**APPLICATION FOR PERMISSION
UNDER SECTION 16 OF
THE TOWN PLANNING ORDINANCE
(CAP. 131)**

For Official Use Only 請勿填寫此欄	Application No. 申請編號	A/SK - CWBN/77
	Date Received 收到日期	25 JUN 2024

**Proposed Filling and Excavation of Land
for the Permitted "Agricultural Use" in "Conservation Area"
at Various Lots in DD238 in Clear Water Bay
- S16 Planning Application -
TPB Ref. A/SK-CWBN/77
[Further Information No. 1]**

Response-to-Comment Table

Figure 2.3

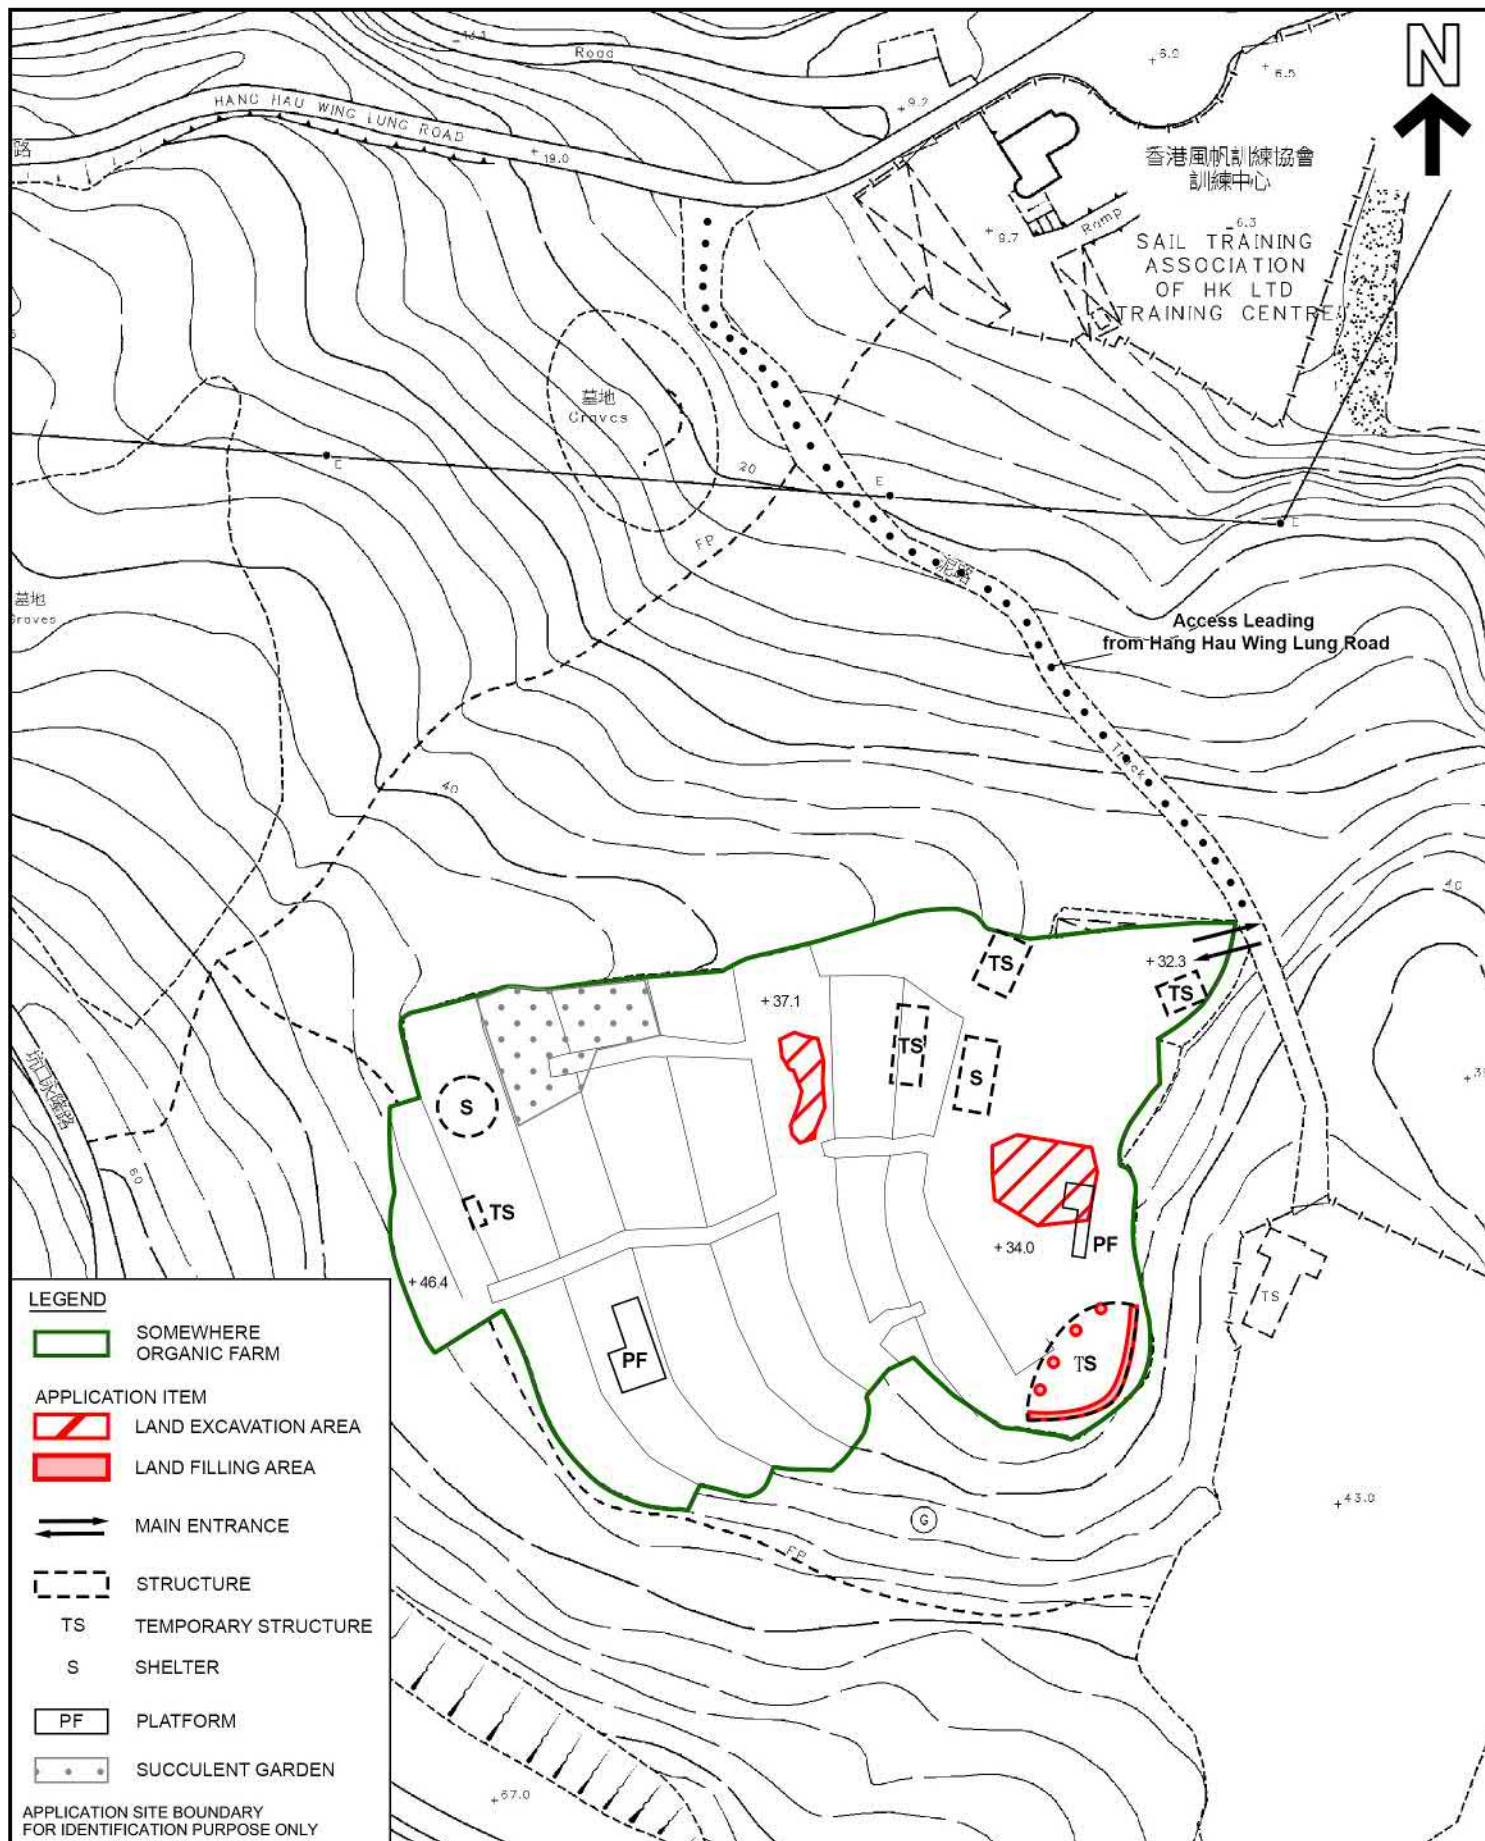
Comments	Response
<p>Email dated 17 July 2024 refers:</p> <p><u>Comments from Sai Kung & Islands District Planning Office, Planning Department:</u> (Contact Person: Mr Benjamin LEE Tel: 2158 6144)</p> <p><u>Layout Plan of the Farm</u> (Figure 2.3 of the Planning Statement)</p> <ol style="list-style-type: none"> 1. Indicate the areas in the Farm associated with specific types of agricultural activities stated on the Planning Statement (crop farming, plantation area, hydroponics, fish cultivation, rain water harvesting, etc.) 2. Supplement the construction materials/method, function and size of the structures annotated as ‘Shelter’, ‘Temporary Structure’ and ‘Platform’, and elaborate how the structures at the Farm can support agricultural activities. 3. In addition to the bamboo shelter as staff/volunteer resting space, clarify if there are any structures for use by staff or visitors (e.g. staff toilets and kitchen). Please also clarify if there are waste management and/or sewerage facilities on the Farm and indicate on the plan if any. <p><u>Operation Details of the Farm</u></p> <ol style="list-style-type: none"> 1. Para. 3.4.8 of the Planning Statement states that “The landowner also welcomes volunteers to experience farming. The Farm is 	<p>Consumables</p> <p>Please kindly note that the entire area of the Farm is used for planting of various crops (subject to seasons). The Layout Plan has been updated to indicate the agricultural land and facilities that are ancillary to the farming activities at the Farm, such as shelters, storages and platforms. Please refer to <i>Appendix I</i>.</p> <p>The storages and shelters are all temporary structures placed on grade with simple construction methods similar to any other farm structures. These are created by wood, tiles, metal frames, metal sheets, polyethylene sheet, bamboo and etc. Dimensions of the temporary structures are annotated in the Layout Plan.</p> <p>Basic hygienic equipment (such as washing basin and toilet) is provided at the Farm. There is a septic tank to treat the foul water.</p>

Appendix I
Revised Layout Plan

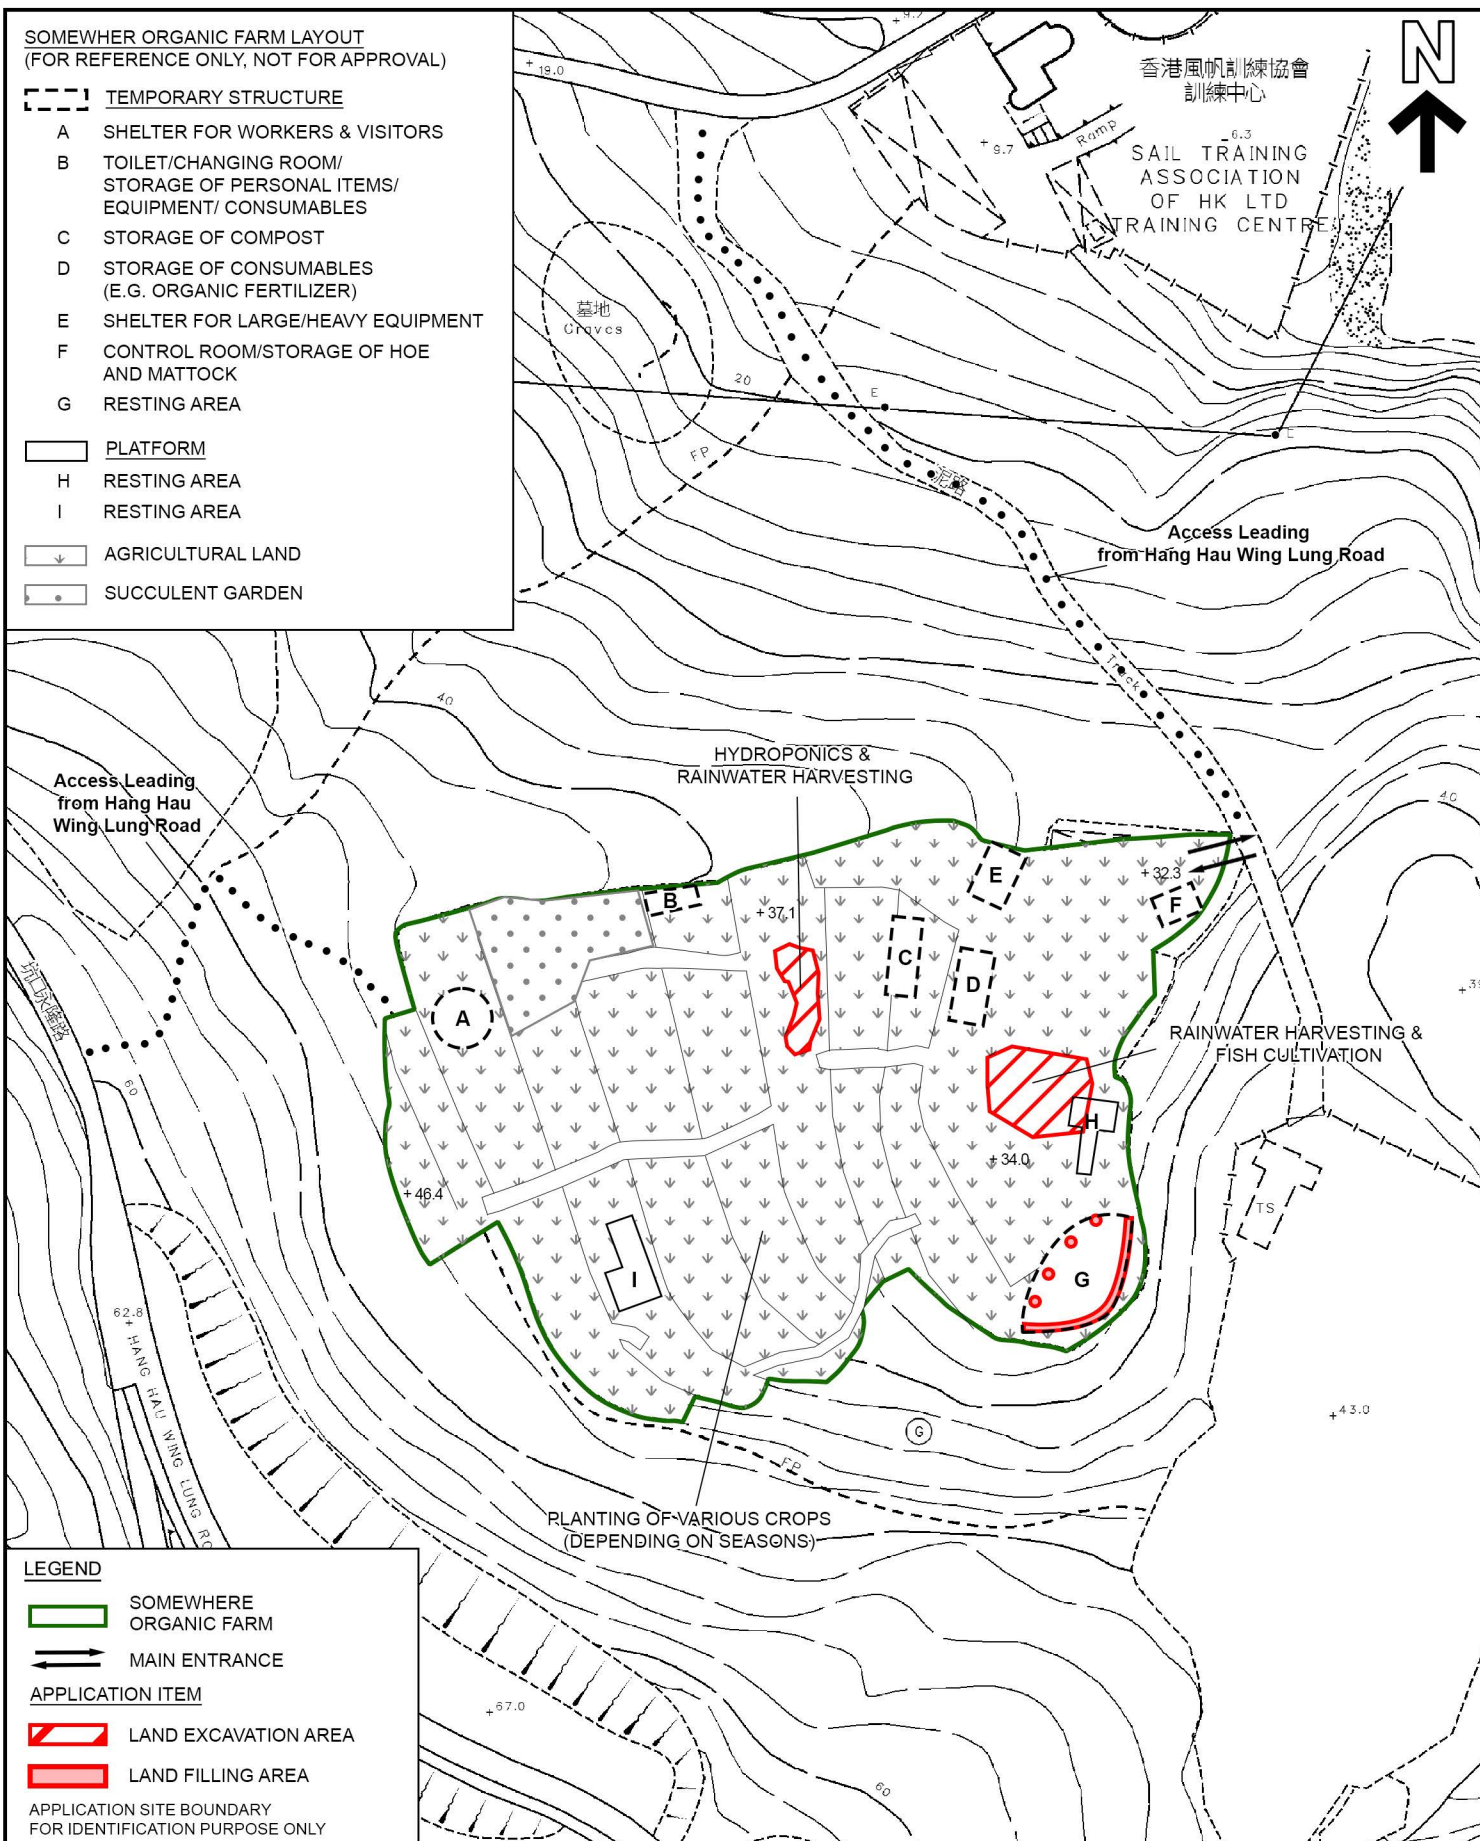
<p><u>Applied Excavation and Filling of Land</u></p> <ol style="list-style-type: none"> 1. Please clarify whether the applied excavation and filling of land under the current application reflect the completed excavation/filling works for the existing ponds and bamboo shelter respectively. 2. Para. 3.5 of the Planning Statement - Noting that Enforcement Notice and Reinstatement Notice have been issued to the Farm, please provide the latest progress of the reinstatement works. 	<p>Correct, the applied excavation and filling of land under the current application reflect the completed excavation/filling works for the existing ponds and bamboo shelter and no addition excavation or filling of land will be carried out.</p> <p>The Landowner has been constantly liaising with the Central Enforcement and Prosecution Section of the Planning Department in relation to the reinstatement works. The Landowner has made an effort in fulfilling the requirements, such as reducing the extent of the coverage of gravels at the succulent garden, disseminating the platform</p>

Comments	Response
	tiles to demonstrate the platforms do not involve any filling or excavation of land and etc.. Other reinstatement works (i.e. filling of ponds) shall be considered after the Town Planning Board has made decision on the current application.

Appendix I
Revised Layout Plan

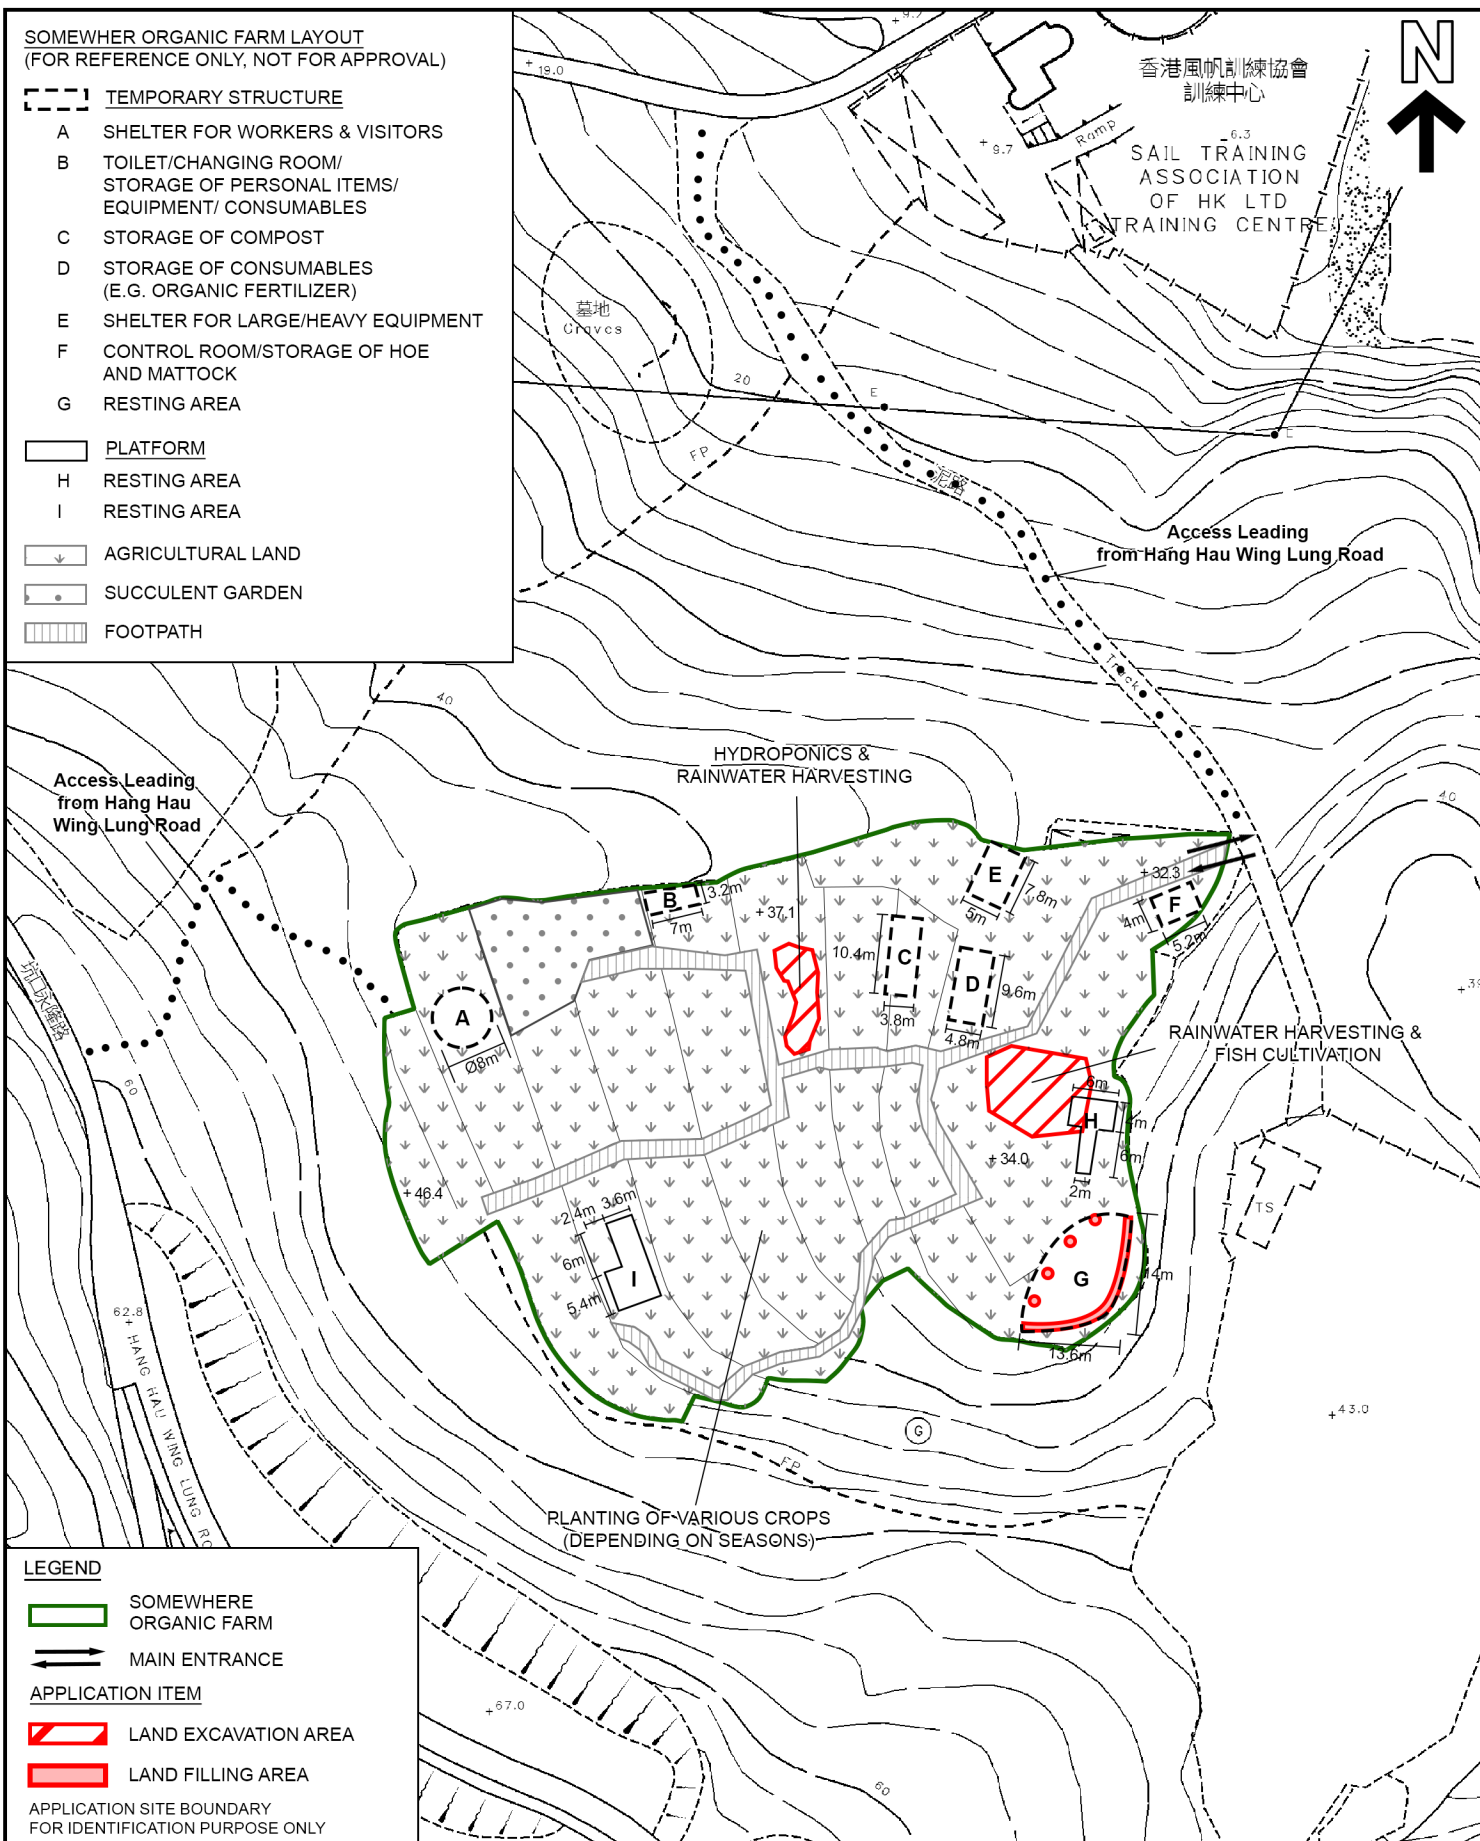
Comments	Response
<p><u><i>Applied Excavation and Filling of Land</i></u></p> <p>1. Previous site inspections reveal that the upper pond appears to have been filled. Please clarify the extent of the completed excavation/filling works under the subject application.</p>	<p>Please be confirmed that the total area of the upper pond (i.e. about 49sqm) has already included the concrete lining that has been identified as ‘filling of land’ by the Central Enforcement and Prosecution Section. The said concrete lining involves a thickness of about 50mm.</p>
<p>Email dated 29 July 2024 refers:</p> <p><u>Comments from Drainage Services Department:</u> (Contact Person: Mr Andy Kwun-wa WONG Tel: 2300 1294)</p> <p>The applicant shall provide detailed drainage proposal to demonstrate that sufficient drainage have been provided to intercept all surface run-off at the concerned location.</p>	<p>Please kindly refer to the revised Drainage Impact Assessment in <i>Appendix II</i>.</p>

Comments	Response
<p><u><i>Advisory Remarks to Applicant</i></u></p> <p>The applicant is reminded that approval of the application under Town Planning Ordinance does not imply approval of tree works such as pruning, transplanting and felling. Applicant is reminded to approach relevant authority/ government department(s) direct to obtain necessary approval on tree works.</p>	<p>Noted, but as previously mentioned, no additional filling and excavation of land will occur, no adverse impact would be induced in the future and the Farm shall remain as it is.</p>
<p>Email dated 23 July 2024 refers:</p> <p><u>Comments from Sai Kung & Islands District Planning Office, Planning Department:</u> (Contact Person: Ms Sylvia Lam Tel: 2158 6165)</p> <p><u><i>Layout Plan of the Farm (Figure 2.3 of the Planning Statement)</i></u></p> <p>1. It is noted that the Farm is used for seasonal crop planting. Please provide an approximate range of the farming area / farming terrace (net of internal circulation space, footpath, and temporary structures) in terms of sq.m or percentage of the entire Farm</p> <p>2. Dimensions of the temporary structures are missing from the Layout Plan. Please revise.</p>	<p>The Farm has a total area of 6,175sqm, please see below the areas of different uses within the Farm:</p> <p>Temporary structures (for storage; Items B-F) – about 168sqm Areas for resting (Items A & G-I) – about 290sqm Ponds: about 190sqm Footpath/internal accesses: about 475sqm Areas for agricultural purpose: about 5,052sqm (i.e. about 82% of the Farm)</p> <p>Please refer to the updated Layout Plan attached.</p>
